EVERLIGHT Electronics Co., Ltd.

- PRODUCT/PROCESS CHANGE NOTIFICATION**
 PRODUCT TERMINATION NOTIFICATION(※2)

PCN tracking number: PRM20130801

Product influenced: 45-21/KK2C Lighting

A. Phosphor Color

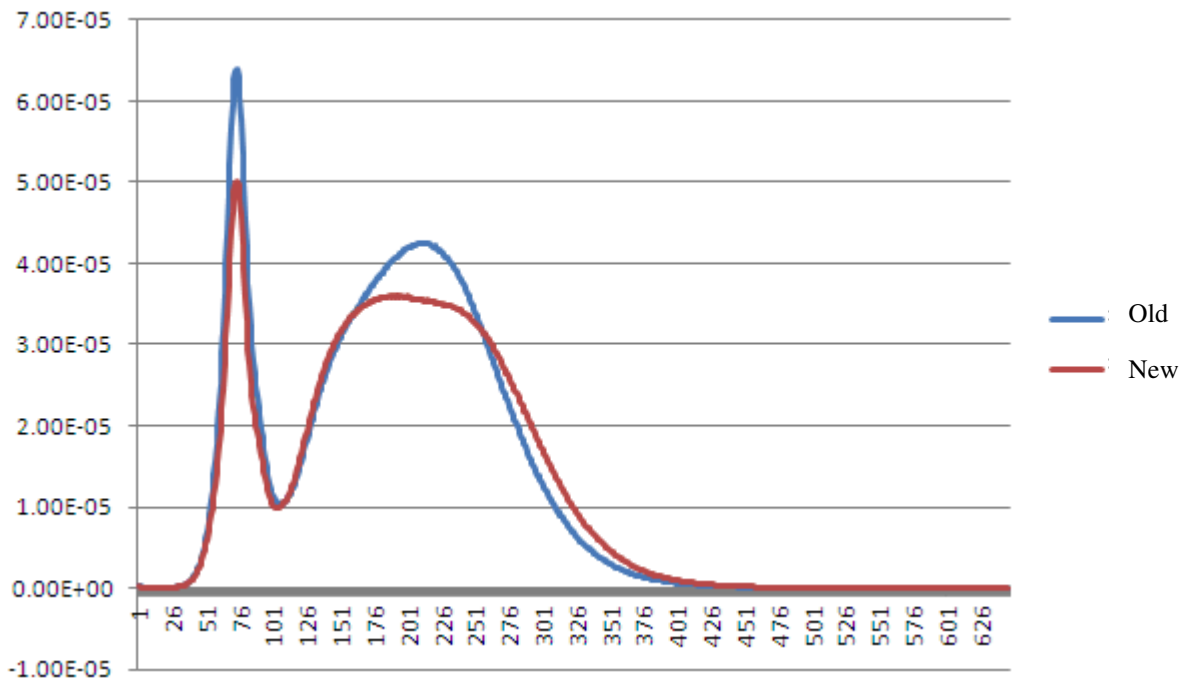
In order to improve and stabilize CRI output, we perfect the phosphor combination. Since the material combination has been adjusted, the appearance is changed accordingly. There's no difference in RA result and specification.
